TECHNICAL BULLETIN

New Sight Glass Position

Bulletin #:	Rev:	Created by:	Date:
00-120965-0	B	RZV	2021-01-18

ECR #	85162	Production: <input checked="" type="checkbox"/>	Service: <input checked="" type="checkbox"/>	Sales: <input checked="" type="checkbox"/>
Product Lines:		Transportation Equipment: <input checked="" type="checkbox"/>	Pneumatic Equipment: <input checked="" type="checkbox"/>

Figure 1: New Sight Glass Position 510

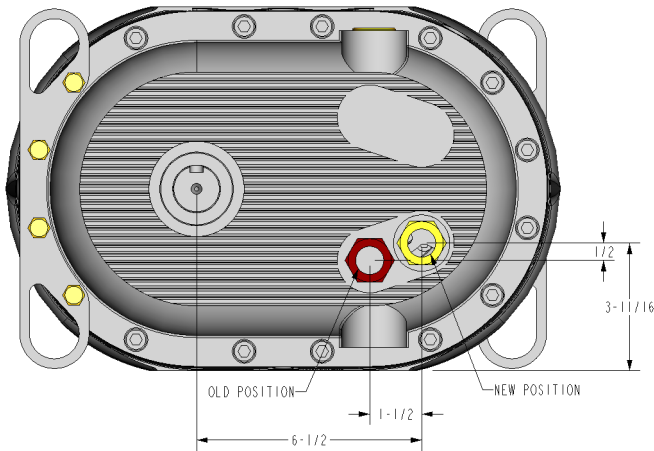
The volume of oil in the drive side of the blower has been increased by 150 mL on the model 510 blower, and 300 mL on the model 614 blower. This change was made in an effort to extend blower life, and improve the condition of the oil on the drive side of the blower.

Because of this change the sight glass, used to determine oil level, has been repositioned. The new location of the sight glass is raised up 1/2" for both model 510 and 614 blowers, 1-1/2" further from the drive shaft for model 510 blowers, and 1-1/2" closer to the drive shaft for model 614 blowers (see figure 1 and 2).

Figure 3: Sight Hole Position and Cover

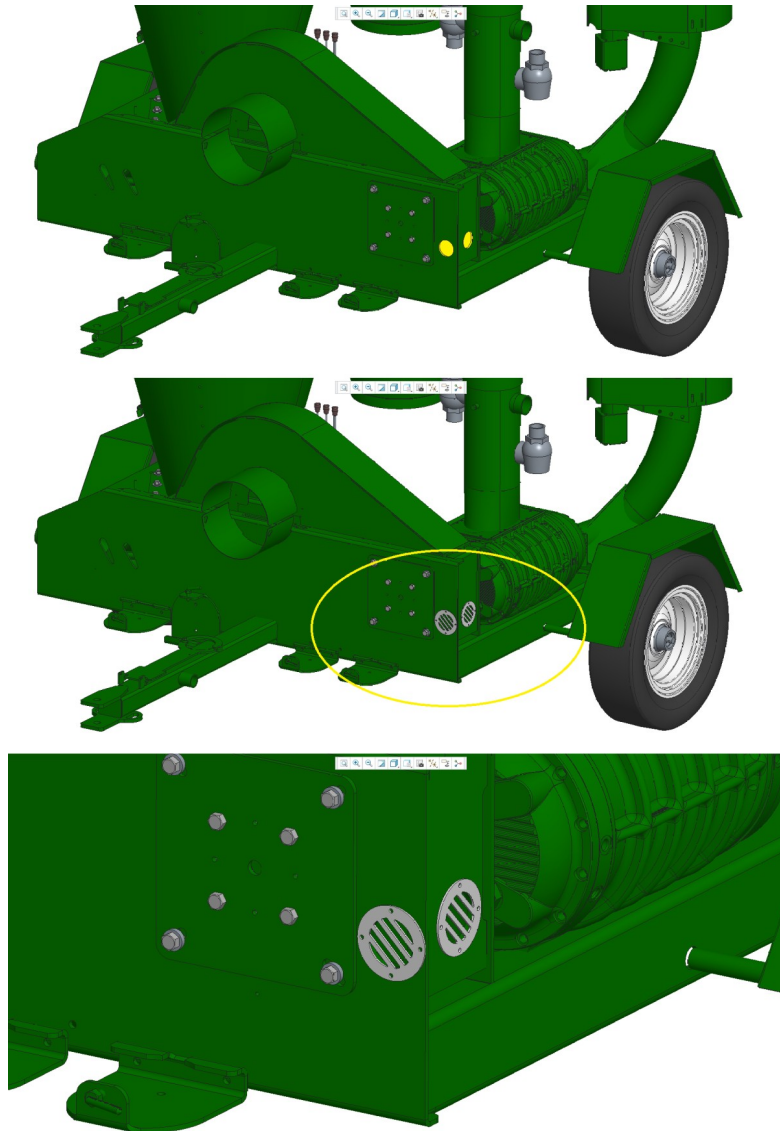
Option 2: A hole may be cut into the frame for the sight glass to fit into.

- a) Using a 1-3/4" drill or hole-saw, cut a hole in the belt housing where the blower meets the frame, in the location specified in figure 1 or 2 depending on your blower model.
- b) With the sight glass installed in the new position, it may be difficult to clearly observe the oil level. To help improve sight glass visibility, using a drill or hole-saw, cut an additional hole, 2-1/2" diameter, into the frame in a position that would allow visibility of the sight glass. Then use 3/16" self drilling/self tapping screws to fasten the cover (11-132787-4) in place, ensuring that the unit remains safe to operate.
- c) Figure 3 shows some examples of where to cut the holes, and how install the cover, however each unit is different and it may be valuable to position the opening in another location.
